<b>Office Action Summary</b>	<b>Application No.</b> 10/519,591	<b>Applicant(s)</b> JANSEN ET AL.	
	<b>Examiner</b> THOMAS W. IRVIN	<b>Art Unit</b> 3683

## **DETAILED ACTION**

Fig. 8 (US 6,394,248)

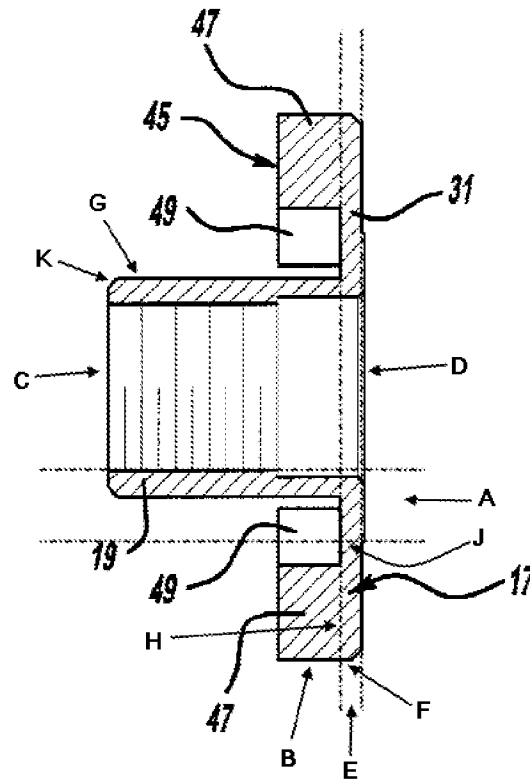
In Re claim 2, see body (A) in Fig. 8 shown above.

In Re claim 3, see cylindrical outer surface (G) which is between first and second ends (C and D).

In Re claim 4, see flange, shelf (47), and outer flange surface (B). Examiner notes that in the apparatus, as modified, there would only need to be a single slot formed by the shelf.

In Re claim 5, see second flange (E) and annular surface extending radially between said body and said outer flange surface (H). Examiner notes that in the apparatus, as modified, there would only need to be a single slot formed by the shelf.

In Re claim 6, in the apparatus of Monahan et al. as modified, the helical first slot is formed by the annular surface (H) and the flange (47) for retaining therein said hub

In Re claim 7, the hub includes a reduced diameter portion (19) having an outer mounting surface (G) having a smaller diameter than said body of said hub (J).

In Re claim 8, see abutment surface (K) extending radially between said body and said outer mounting surface.

**Fig. 6 (US6,394,248)**

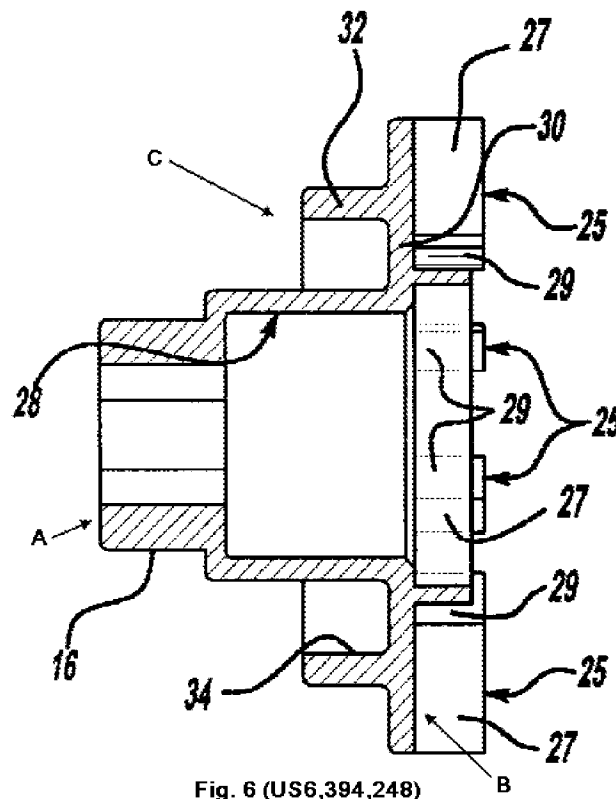
In Re claim 9, with reference to Fig. 6 above, the carrier is ring shaped and extends axially between opposite first and second sides (A and B).

In Re claim 10, in the apparatus as modified, the helical second slot is formed in said second side (B) of said carrier for retaining therein said carrier end of said torsion spring for preventing relative movement between said carrier end of said torsion spring

and said carrier. Examiner notes that in the apparatus, as modified, there would only need to be a single slot formed by the shelf (25).
